# Flagstaff Region 5 Year Plan Review and Update: Review and Responses to Trail Proposals

**BUREAU OF PARKS AND LANDS**  
**NOVEMBER 2013**

# Coburn Gore to Kingfield Trail (WMC)

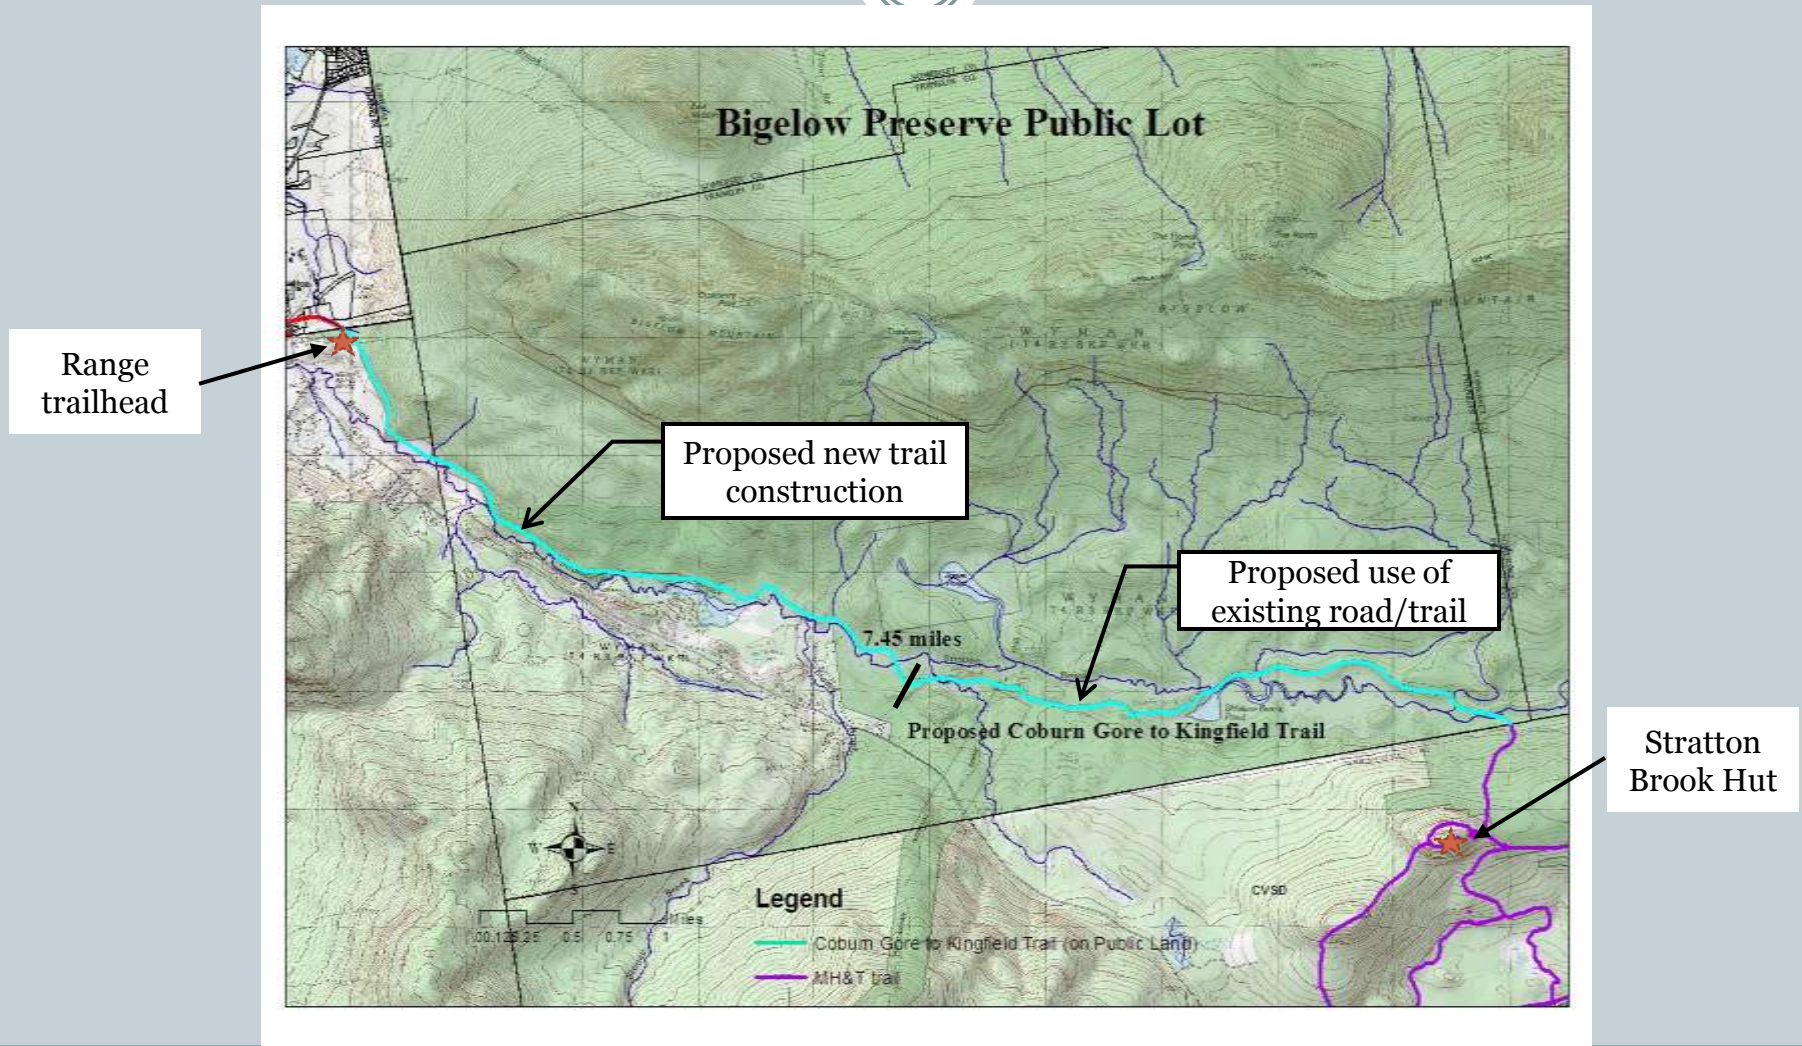
- **Concerns/Constraints**

- A new trail in Preserve, in vicinity of existing management road and snowmobile trail, raises concern of overdevelopment in area designated “Bigelow Backcountry” (p. 126 of Plan)
- BP Act does not allow motorized access/motorized vehicles to be used in construction or maintenance of new proposed trails in the Preserve.
- Proposed linkage with proposed MH&T Stratton Brook Hut trail, which would not be open to mountain bikes

# Stratton Brook Hut-Bigelow Preserve Connector Trail (MH&T)

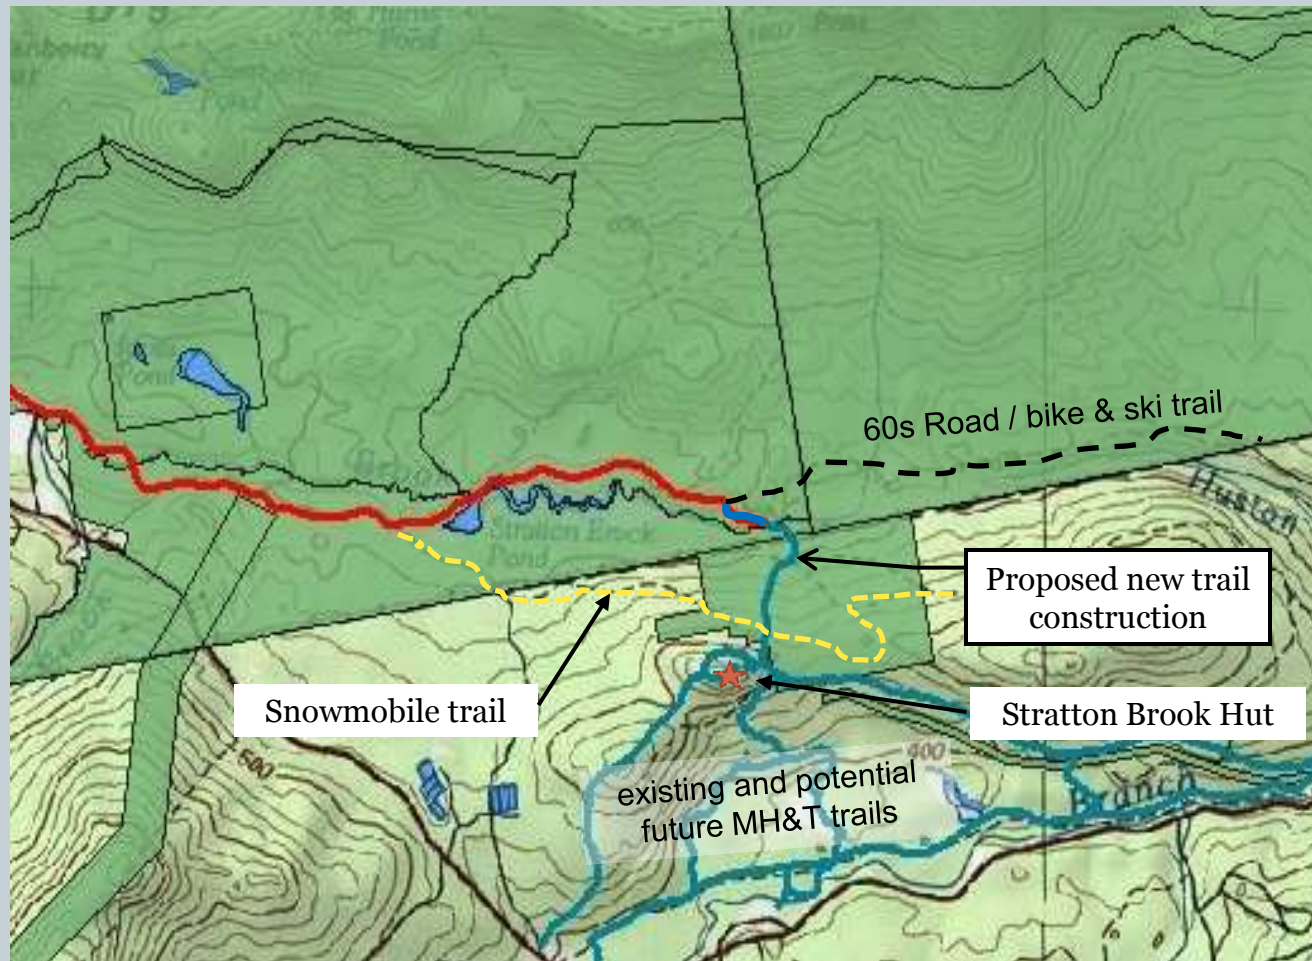
- **Concerns/Constraints**

- Bike riders on 60's Road may be tempted to turn on to new trail, although it would not be open to or designed for bike use
- Bigelow Preserve Act does not allow mechanical equipment to be used in construction of bridge in Bigelow Preserve (applies only to work conducted on north side of brook)

# “Dead Moose Trail” (CR NEMBA)

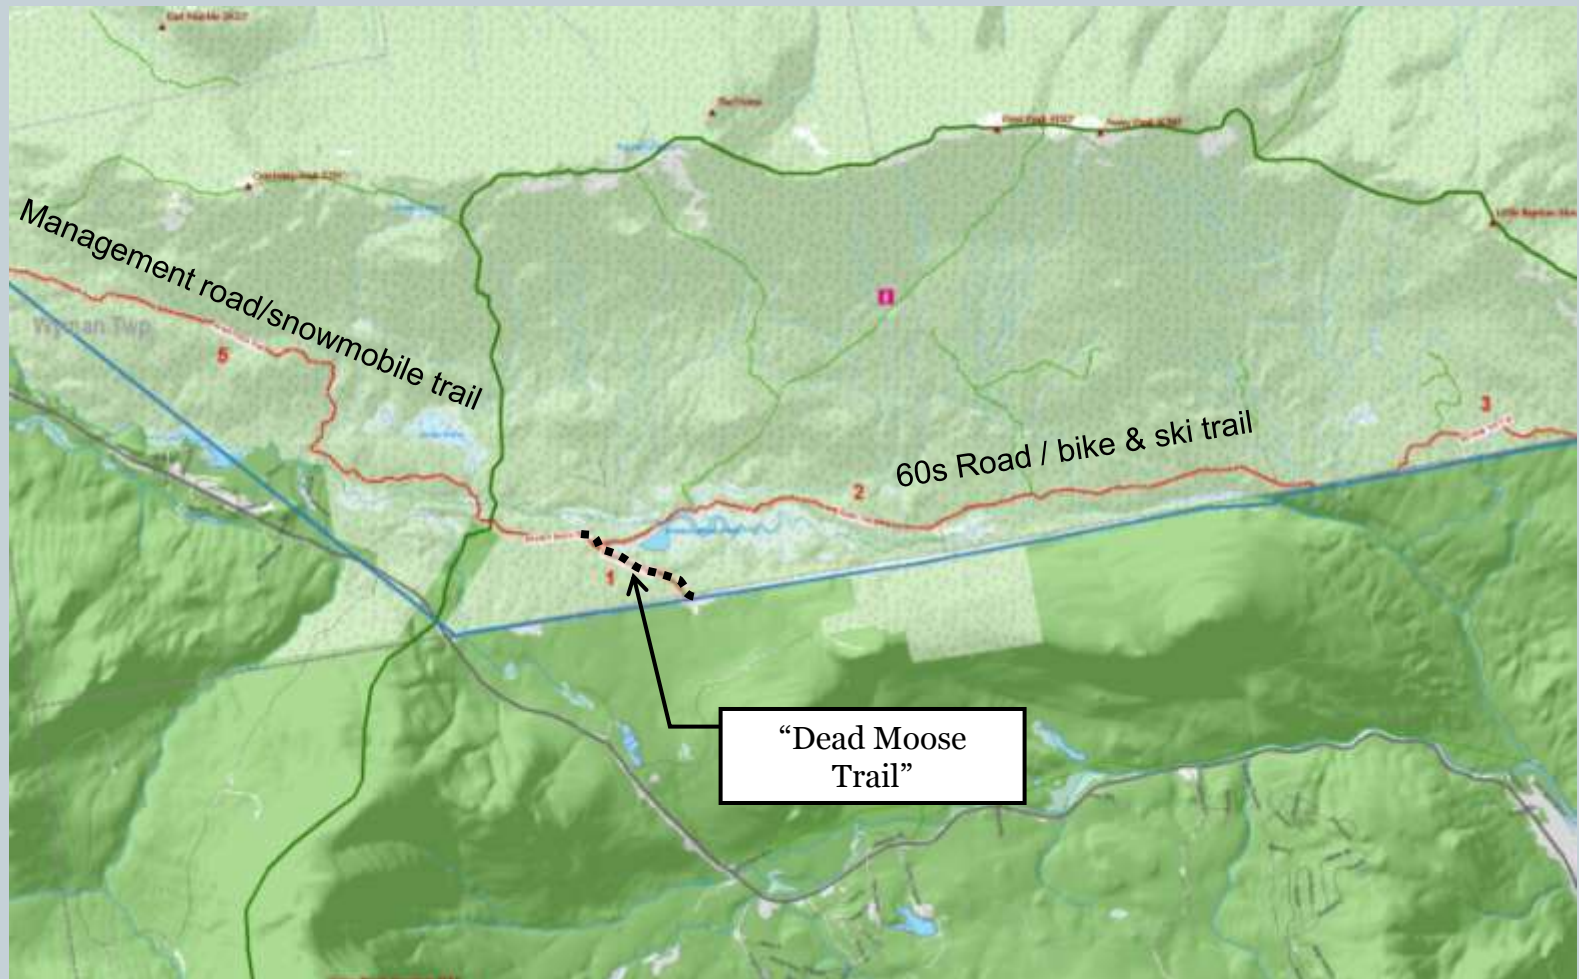
- **Concerns/Constraints**

- Some work on problem areas (e.g., washed out culvert) may be needed before bike use could be authorized
- Proliferation of new designated recreation trails may conflict with timber management activities and increase concern about overdevelopment of the Preserve

# “Esker Trail” (CR NEMBA)

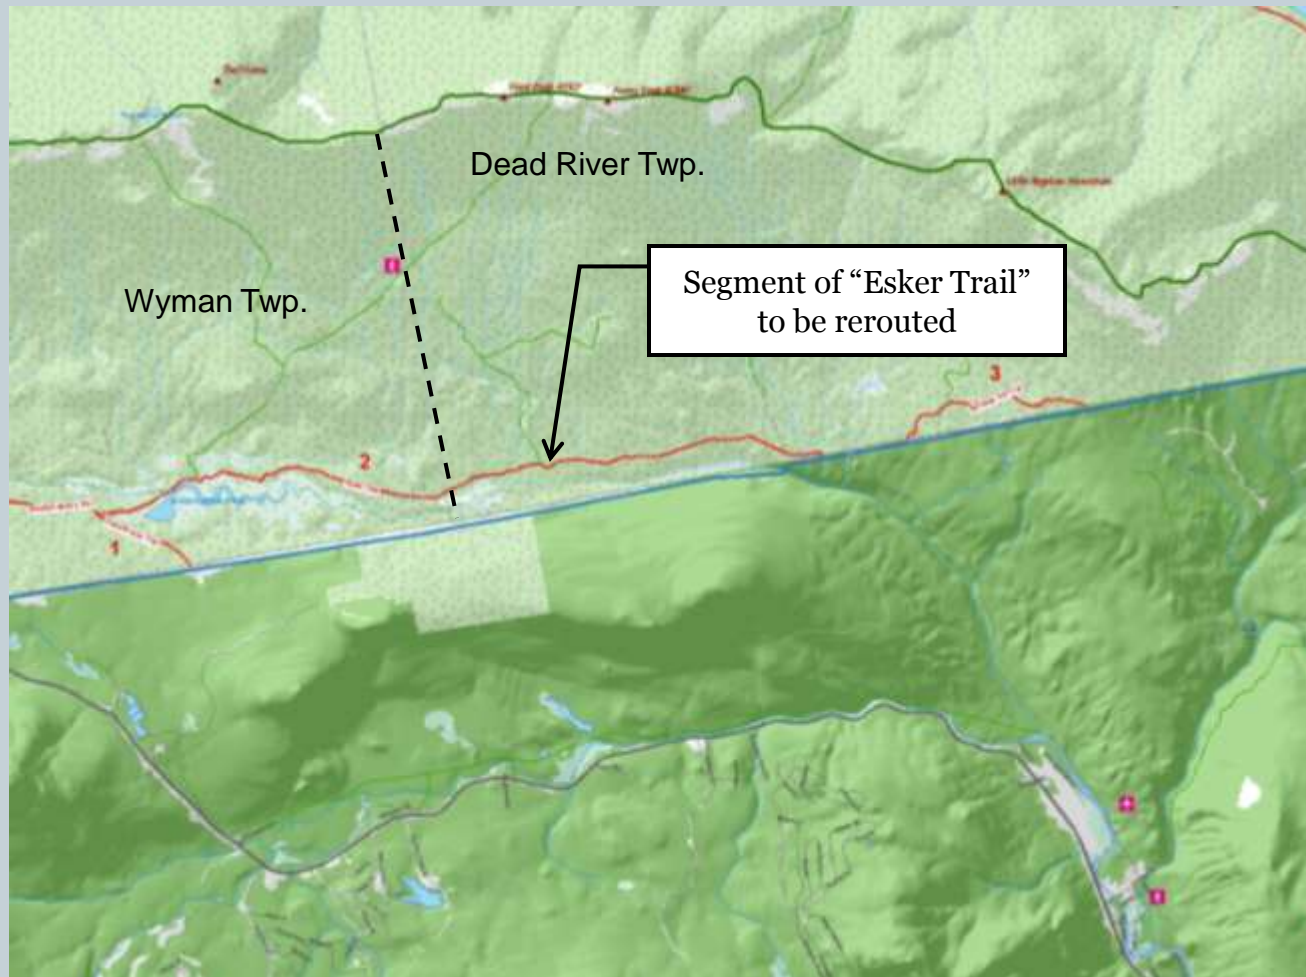
- **Proposal**
  - Reroute existing trail [~2.4 mile section of the 60's Road/ “Esker Trail” within Dead River Twp.] to mitigate for planned use of the road as a haul route during the next few years
  - Purpose: “Trail to provide wilderness experience for users”
- **Concerns/Constraints**
  - Availability of resources to construct rerouted trail ahead of planned harvests

# “Birthday Hill Trail” (CR NEMBA)

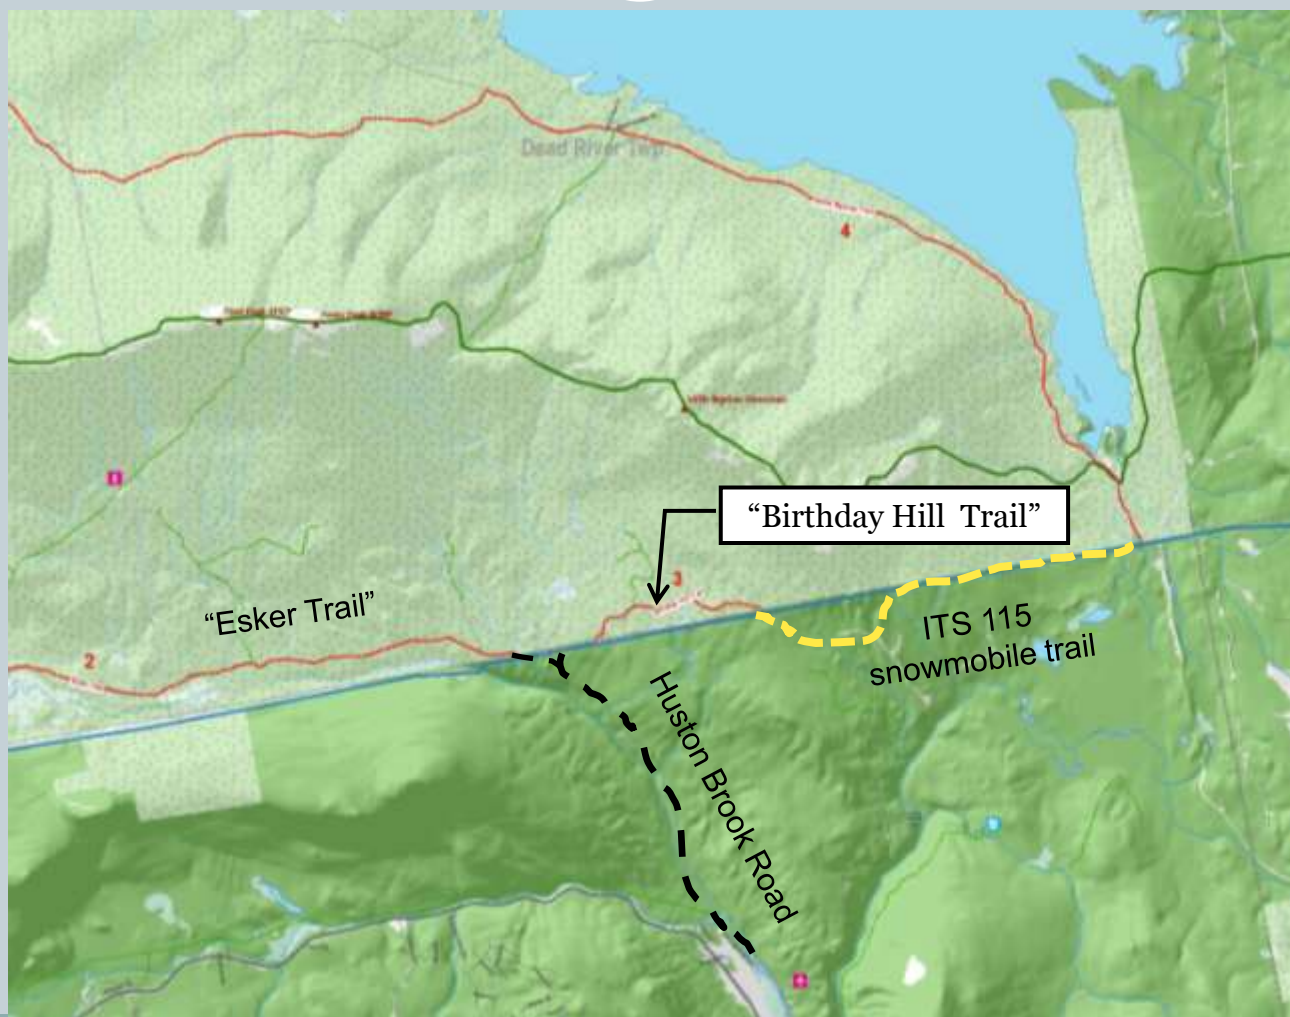
- **Concerns/Constraints**

- Does not link directly to any other bike trails
- Intent of the current Plan is to provide trail connections and touring opportunities on existing roads and as part of the regional mountain bike trail system
- Is it appropriate to develop challenging trails (rather than touring trails) with more intensive use on the Bigelow Preserve?
